## DEPARTMENT OF TRANSPORTATION

### National Highway Traffic Safety Administration

#### New Car Assessment Program (NCAP)

**ACTION:** Final decision.

**Figure 1**

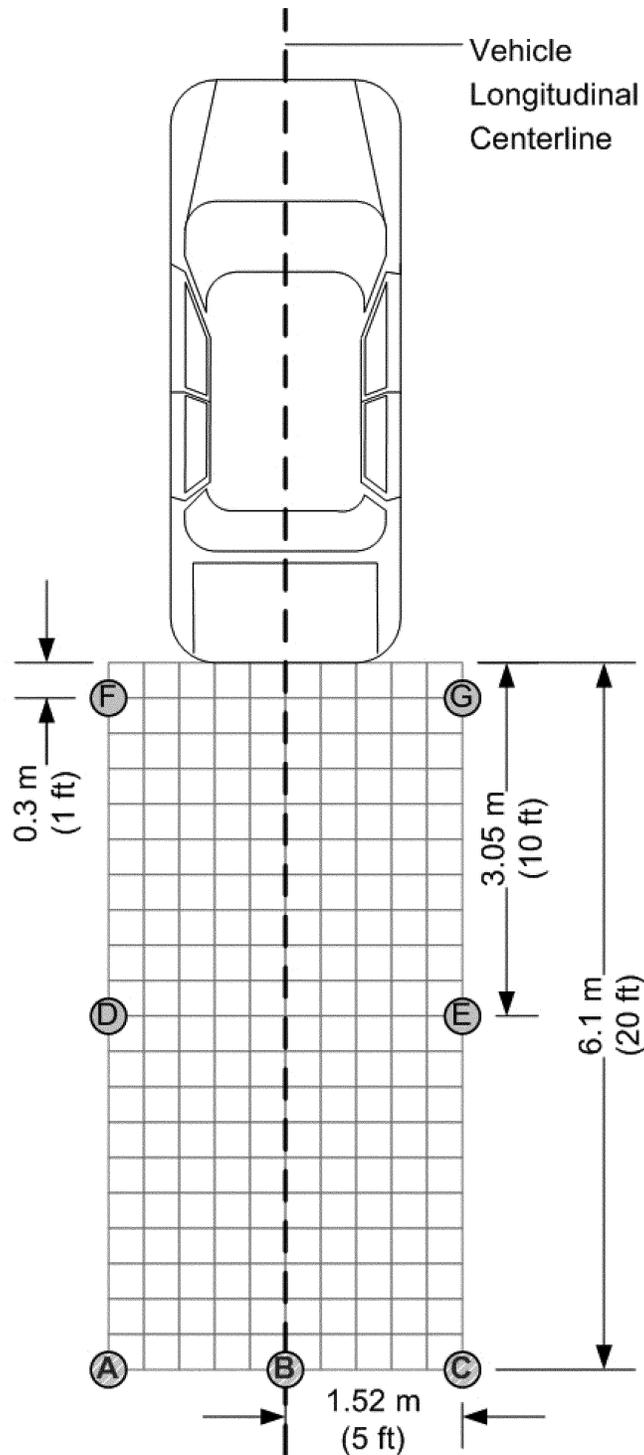
Certain manufacturers expressed two concerns with this test procedure to evaluate the field of view criterion. First, both the Alliance and Global Automakers assert that test objects F and G should be placed in a location that is proportional to the vehicle width (as opposed to 5 feet to the left and right

of the vehicle centerline). They contend that vehicles using a 130 degree camera would not cover the required portions of test objects F and G (in their current locations). Second, the Alliance stated that certain vehicles with a low rear height (i.e., a vehicle that is not high off the ground) has less height flexibility for

mounting a camera. Thus, the Alliance suggests that vehicles with an upper protected surface of the rearmost body structure of 750 mm or less be required to show only a minimum height of 0.4 meters (half the height) of test objects A through E (objects greater than 10 feet from the vehicle bumper).

We disagree with the manufacturers that this procedure for evaluating the field of view criterion does not accommodate vehicles with rearview video systems using a 130 degree camera or vehicles with a low rear height. When we originally developed this test procedure for the NPRM to amend FMVSS No. 111, we specifically designed this test procedure to be able to accommodate these types of vehicle designs. In response to the manufacturers' first concern, it seems clear that if we take into account three-dimensional nature of a camera's field of view, a 130 degree camera will cover the specified areas of all the test objects even if the vehicle has a low rear height. In tests conducted by the agency, the vast majority of vehicles equipped with rearview video systems were capable of meeting the field of view requirements as proposed in the NPRM.<sup>13</sup> Thus, we are unaware of any camera that has a vertical angle limitation which would prevent it from easily being mounted at a pitch which covers the full height of test objects A through E.

In response to the manufacturers' second concern, we note that the portions of the F and G test objects that must be shown are measured by width only in order to accommodate vehicles of varying height and width. Thus, we disagree with the manufacturers that a 130-degree camera is unable to cover the width parameters for test objects F and G. We believe that the diagrams presented by the commenters regarding the inability of the 130-degree camera to cover test objects F and G fail to consider the three-dimensional properties of a camera's viewing angles. As Magna, a rearview video system manufacturer, stated in their comments to the NPRM to amend FMVSS No. 111, a 130-degree camera can readily cover the 5.9-inch (150-mm) width parameters of test objects F and G when mounting height and camera pitch is considered.<sup>14</sup>

Since the available information indicates that existing systems either already conform to (or can be easily adjusted to conform to) the field of view criterion from the June 26, 2013 request for comments, we believe there is no reason to adjust this criterion to reduce the field of view below the 10-foot by 20-foot zone where there is the highest risk of a backover crash.
